Access Compliance Report

Public Rights-of-Way

Intersection ID: 44172	Main Street: SOUTHBROOK_DR	Cross Street: BELLEGARDE_DR	Location: NE
ADA ID: A1EC4BD1490E	Ramp Type: PerpDiag	Initial Pass/Fail: Fail	Overall Compliance: No
		Severity Score: 10

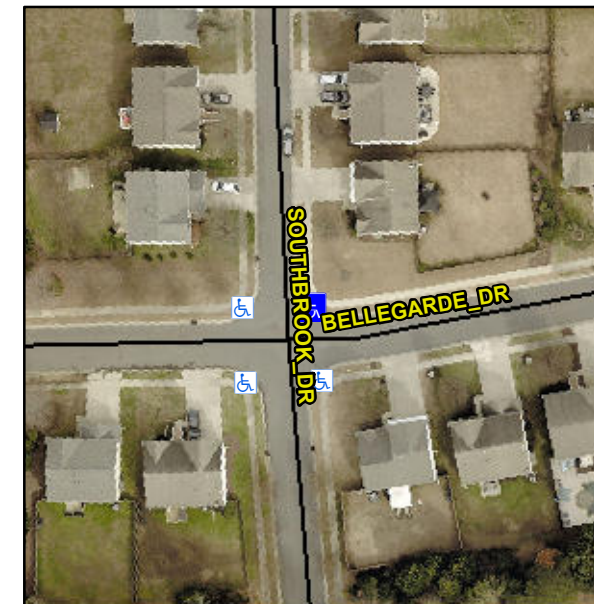
Not Found, R304.5.1, R304.5.3

Compliance	Description	Data	Compliance	Description	Data
N/A	Ramp Length (in)	48.0	Yes	Ramp Slope (%)	5.5
No	Ramp Width (in)	36.0	No	Ramp XSlope (%)	4.2
N/A	Flare Type LT	N/A	N/A	Flare Type RT	N/A
N/A	Flare Slope LT (%)	N/A	N/A	Flare Slope RT (%)	N/A
N/A	Flare Traversable LT?	N/A	N/A	Flare Traversable RT?	N/A
N/A	Landing Length (in)	N/A	N/A	DWS Provided?	N/A
N/A	Landing Width (in)	N/A	N/A	DWS Contrast?	N/A
N/A	Landing Slope (%)	N/A	N/A	DWS Length (in)	N/A
N/A	Landing X Slope (%)	N/A	N/A	DWS Full Width?	N/A
N/A	Landing Curb? (Y/N)	N/A	N/A	DWS Offset (in)	N/A
N/A	Shared Landing?	N/A			
N/A	Gutter Ponding?	N/A	N/A	Gutter Slope (%)	N/A
N/A	Gutter Lip Ht (in)	N/A	N/A	Gutter X Slope (%)	N/A
N/A	Painted X Walk1?	No	N/A	Painted X Walk2?	No
	X Walk 1 Direction	To W		X Walk 2 Direction	To S
N/A	X Walk 1 Width (in)	N/A	N/A	X Walk 2 Width (in)	N/A
	X Walk 1 Slope (%)	4.6		X Walk 2 Slope (%)	0.1
	X Walk 1 X Slope (%)	2.1		X Walk 2 X Slope (%)	2.0

Remove & Replace Curb Ramp With Two New Directional Ramps or Equivalent.
